# **RANCH PLAN**

# **Alternative Development Standards**

March 14, 2007  
Amended August 12, 2008 | Amended September 14, 2011 | Amended December 14, 2011  
Amended March 15, 2012 | Amended July 24, 2013 | Amended November 14, 2014  
Amended May 27, 2015 | Amended September 26, 2018

## Ranch Plan Alternative Development Standards Approvals Summary

ADS  
B-6  
SHEET 1 OF 11

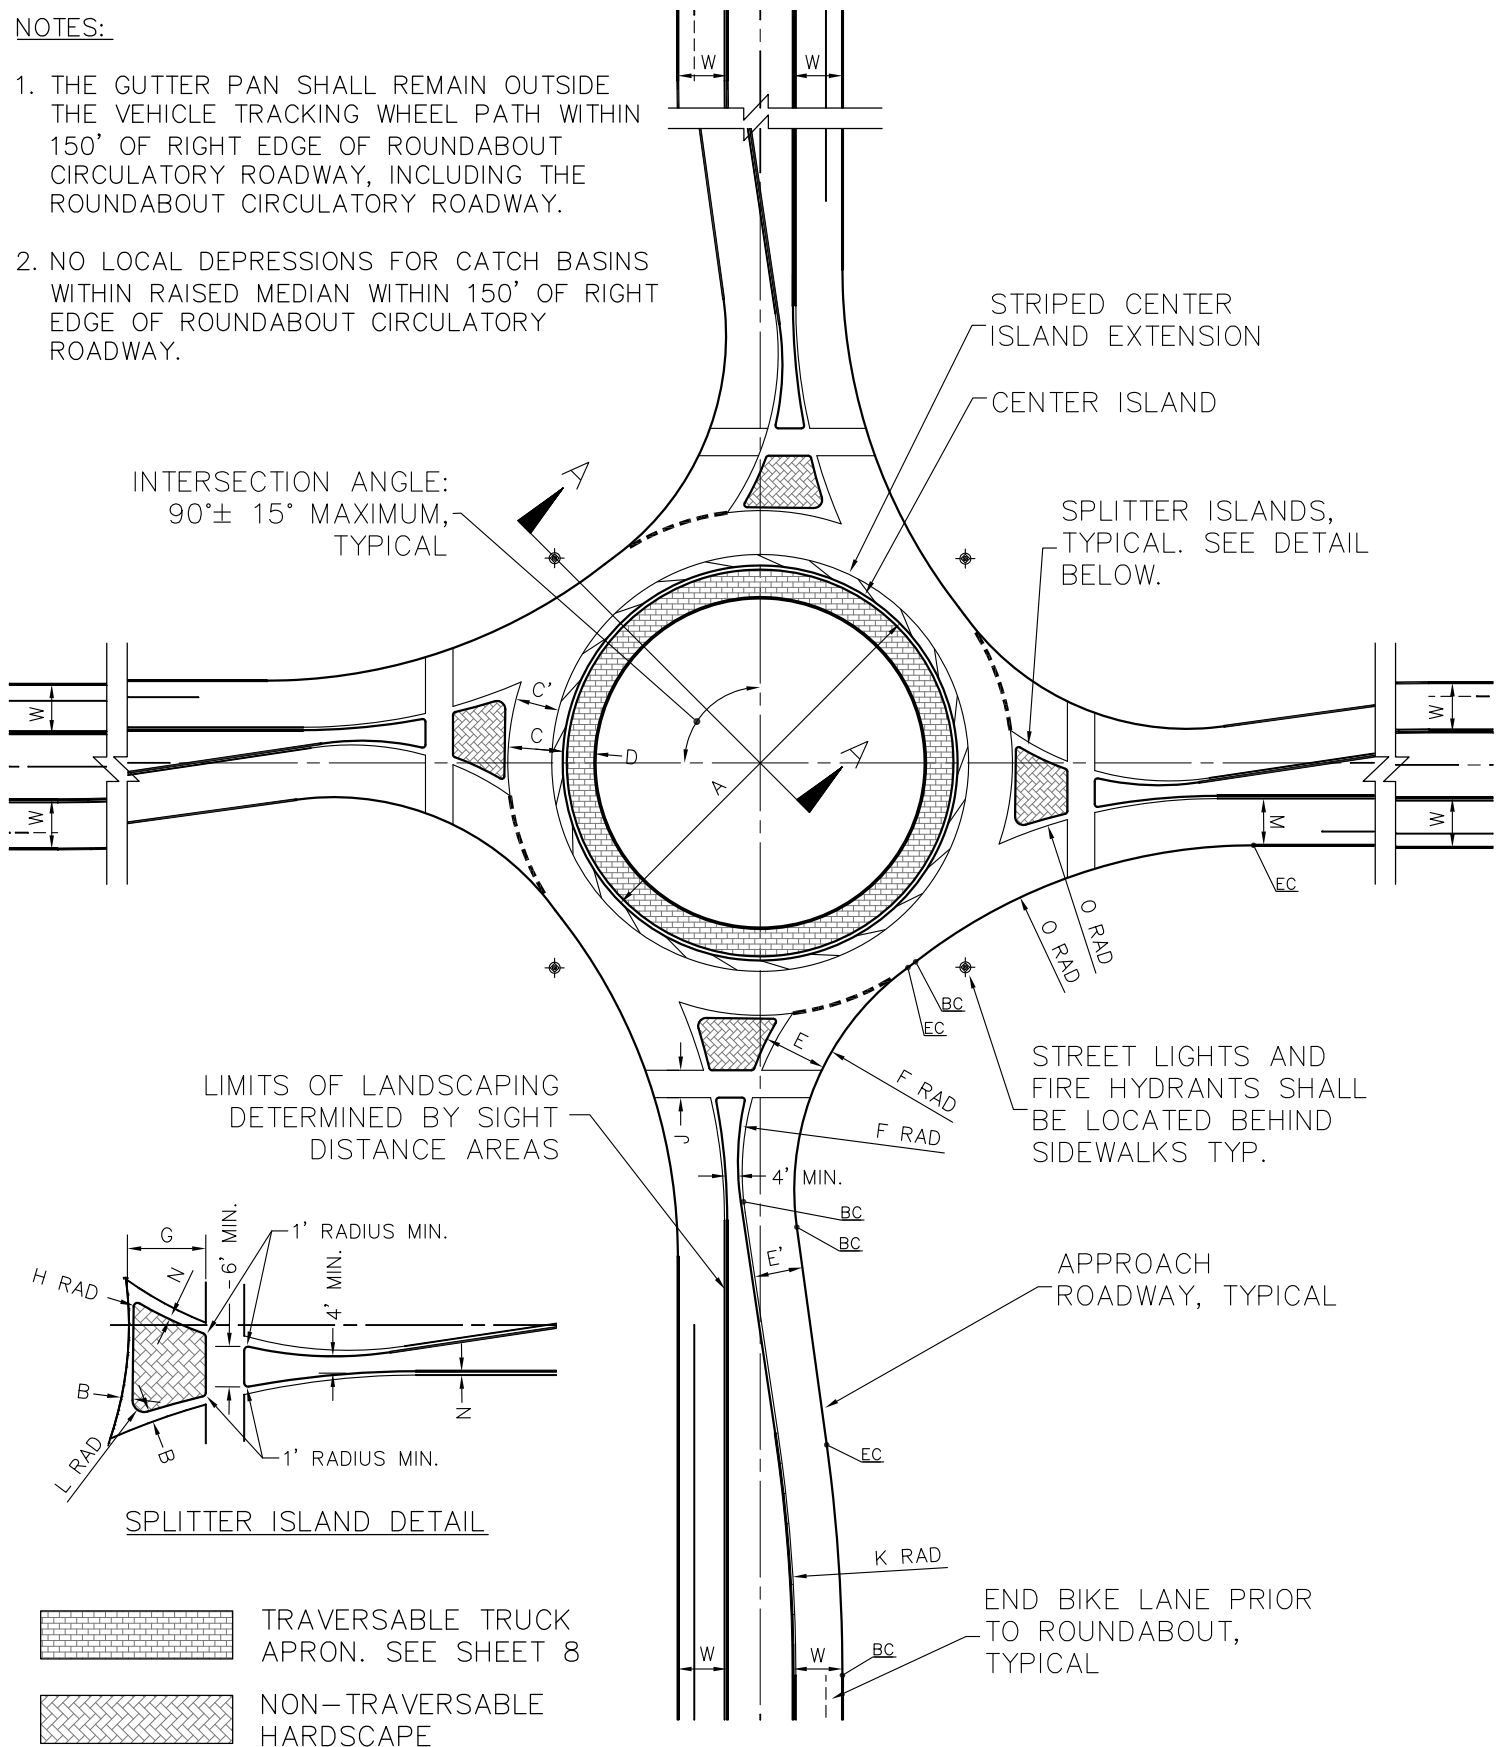
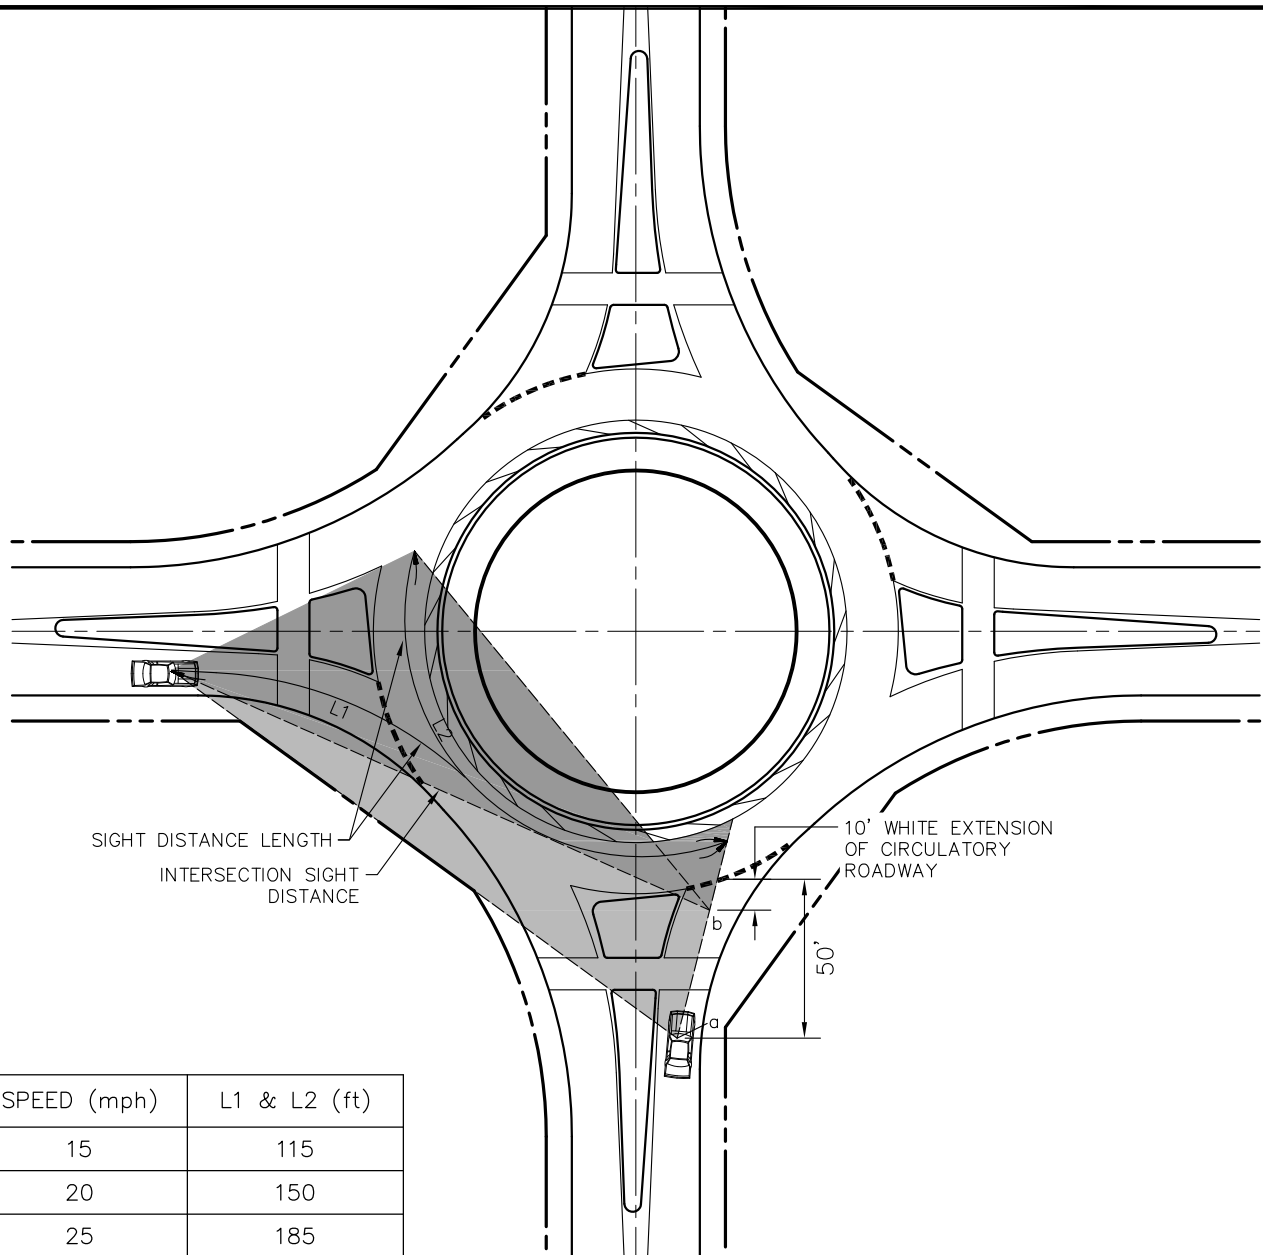
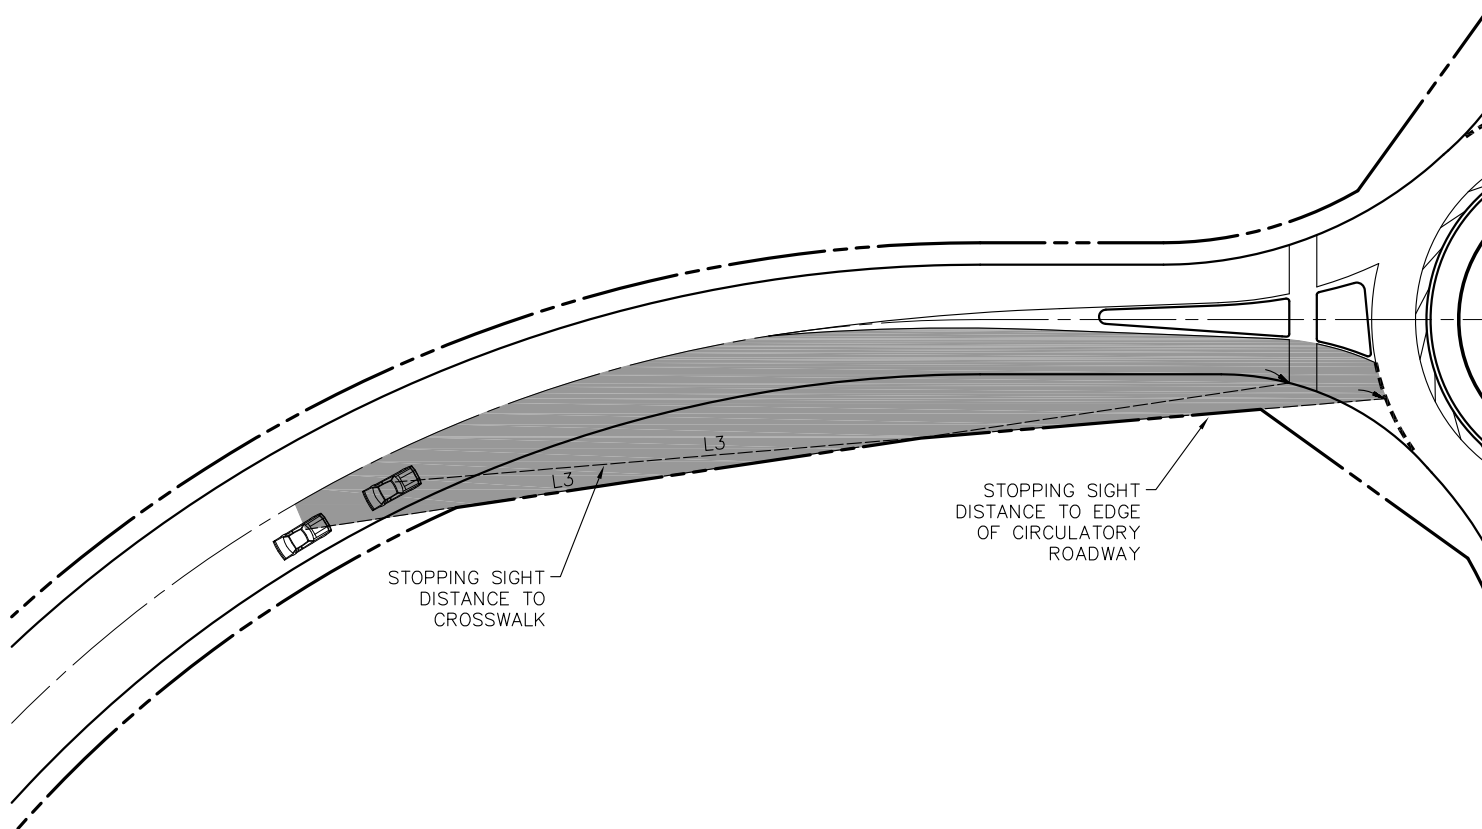
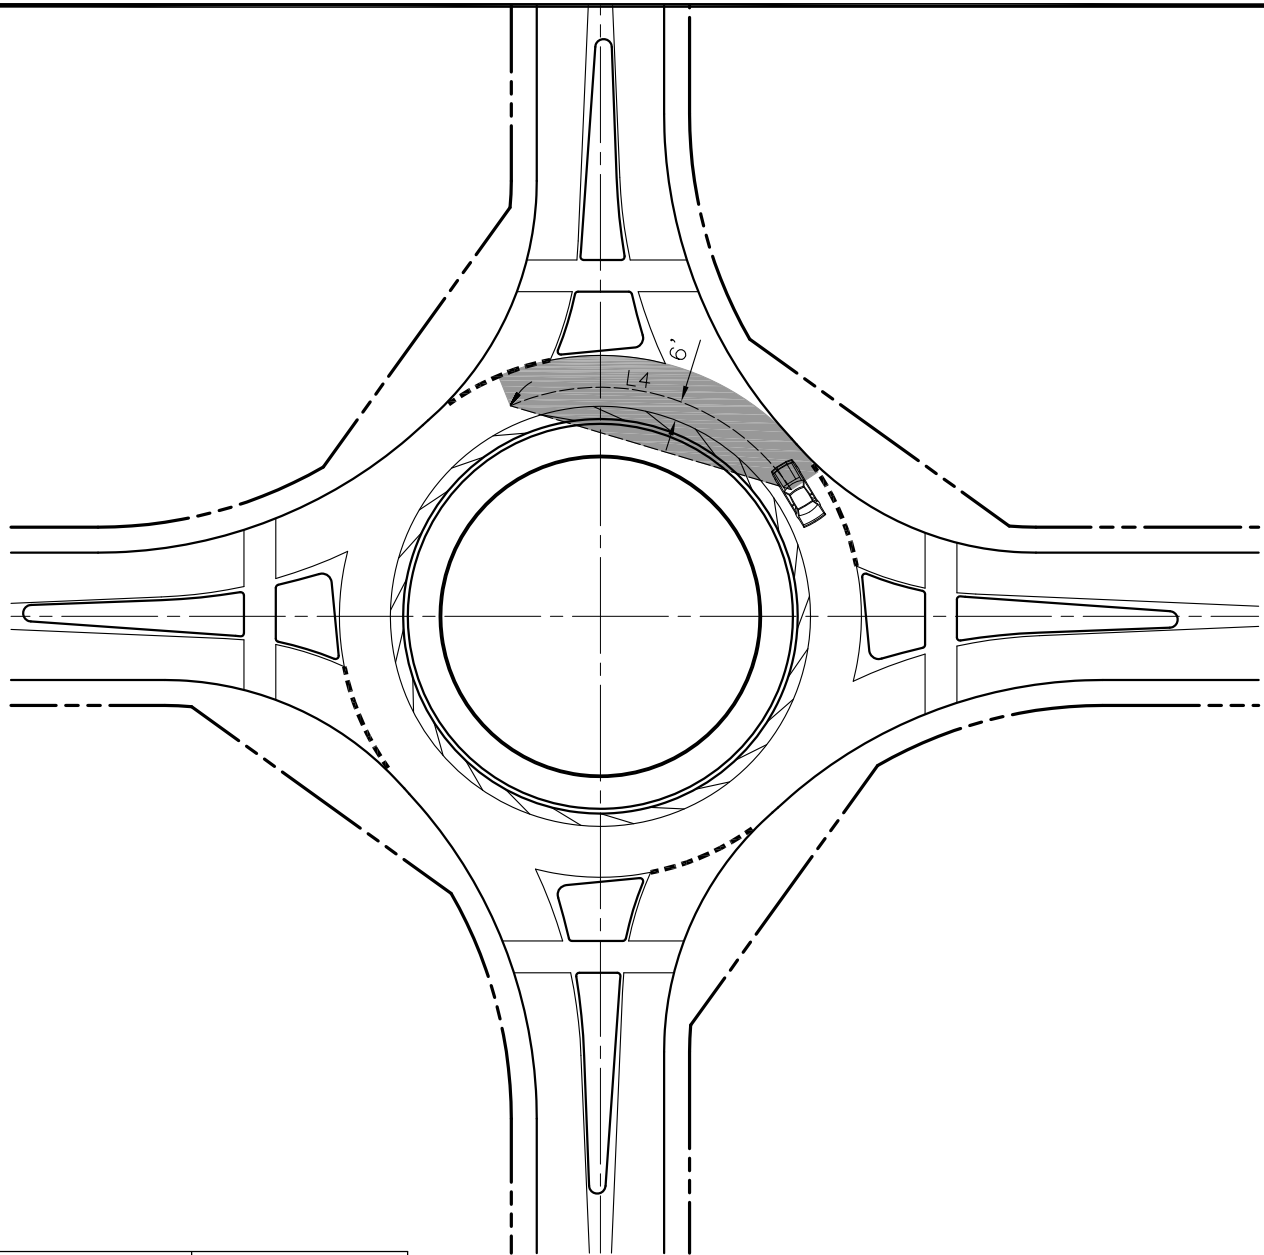
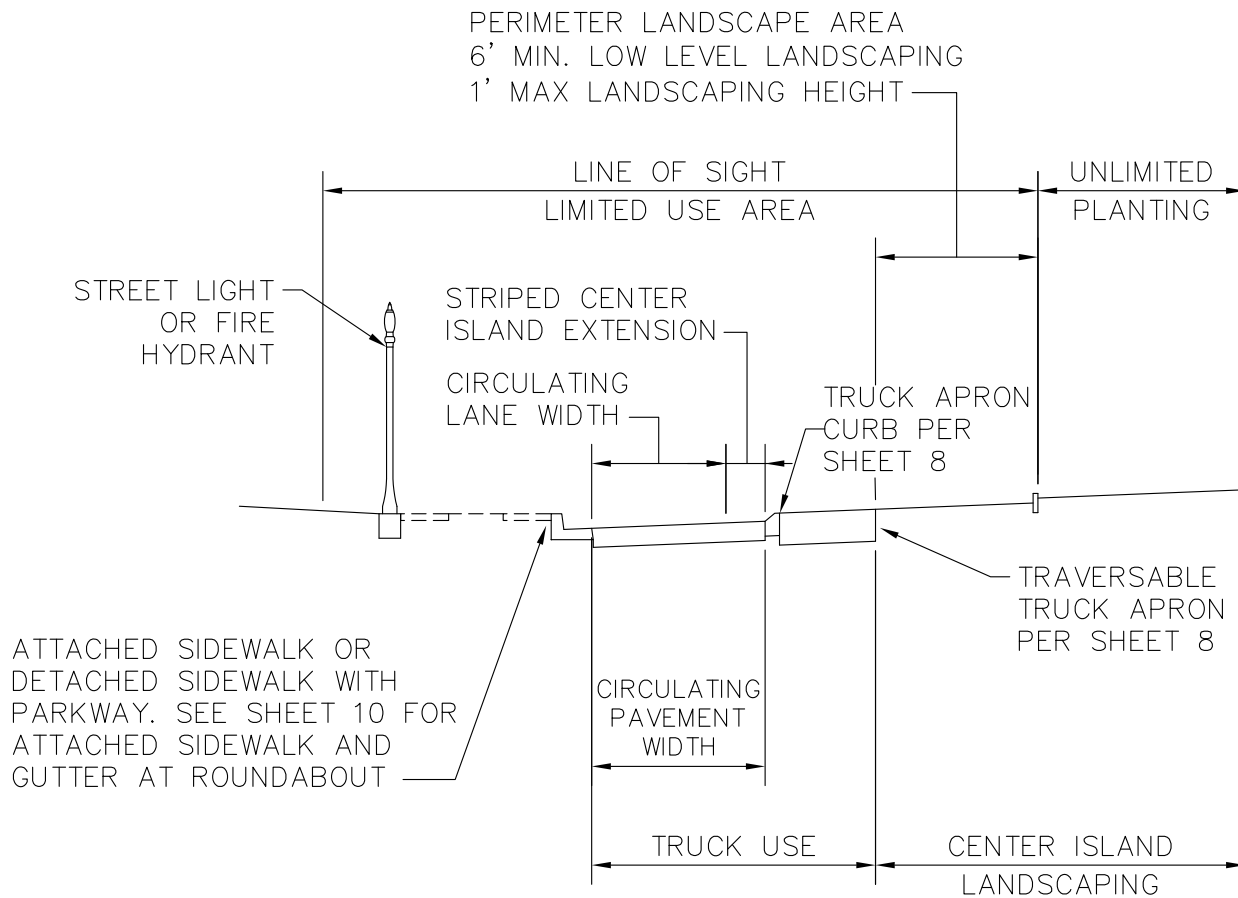
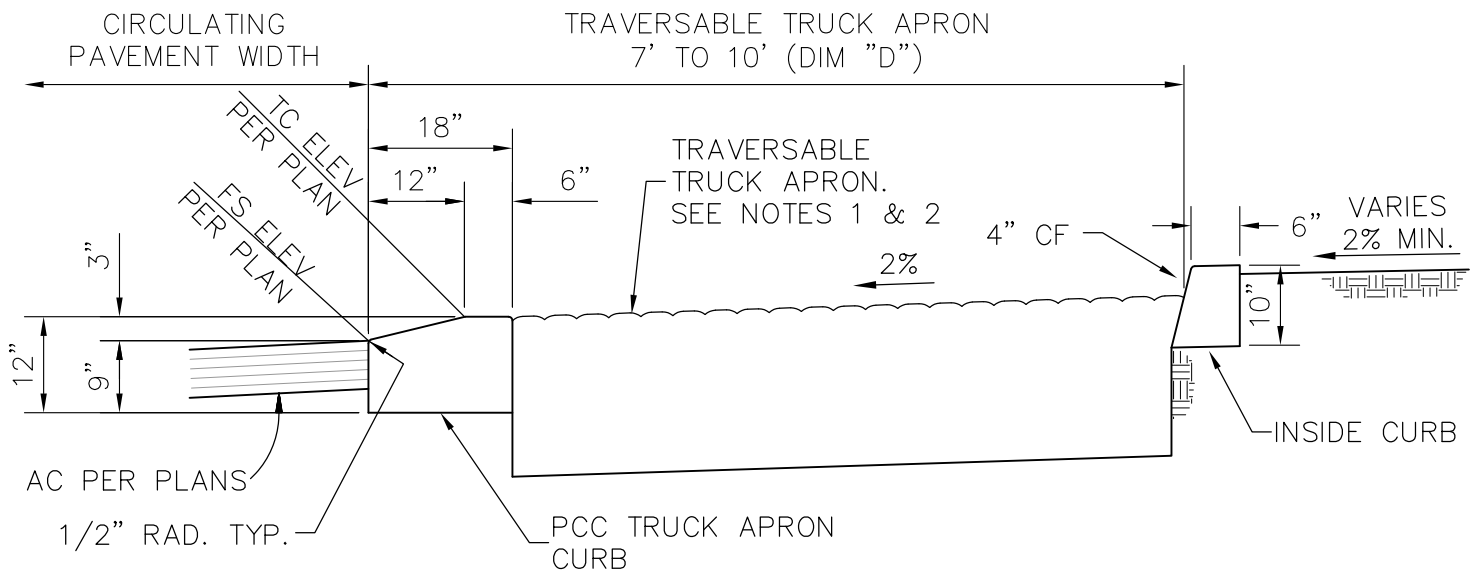
Sheet 1:

Sheet 3: (Previous Sheet 5)

1. Revised and added new dimensions associated with updates to sheets 1 and 2.
2. Added crosswalk setback dimensions based on proximity to schools, recreational, commercial and secondary highway areas.

Sheet 4 (Previous Sheet 3):

1. Removed outside OCFA vehicle apron.
2. Revised roundabout layout to reflect changes on sheet 1.
3. Moved corner right-of-way lines outside the approach and departure sight distance areas.

Sheet 7 (Previous Sheet 4):

Sheet 8 (Previous Sheet 6):

1. Changed detail title from "Wedge Curb detail" to "Truck Apron Detail".
2. Revised detail to remove armored pavement and specified traversable truck apron pavement treatment must be capable of supporting OCFA vehicles.
3. Mirrored detail to match the section callouts on sheet 1 and 2.
4. Added Note 3: Median island landscape shall be designed with area drain system to capture surface drainage (to be shown on landscape plans).
5. Added Note 4: Soil conditions within median island may determine need for additional sub-drain systems.

Sheet 9 (Previous Sheet 7):

1. B-6 – Roundabouts: A proposed modification to the roundabout concrete gutter detail to add a one-inch “batter” (Sheet 7 of 8), per the request of the Manager of Inspection Services.
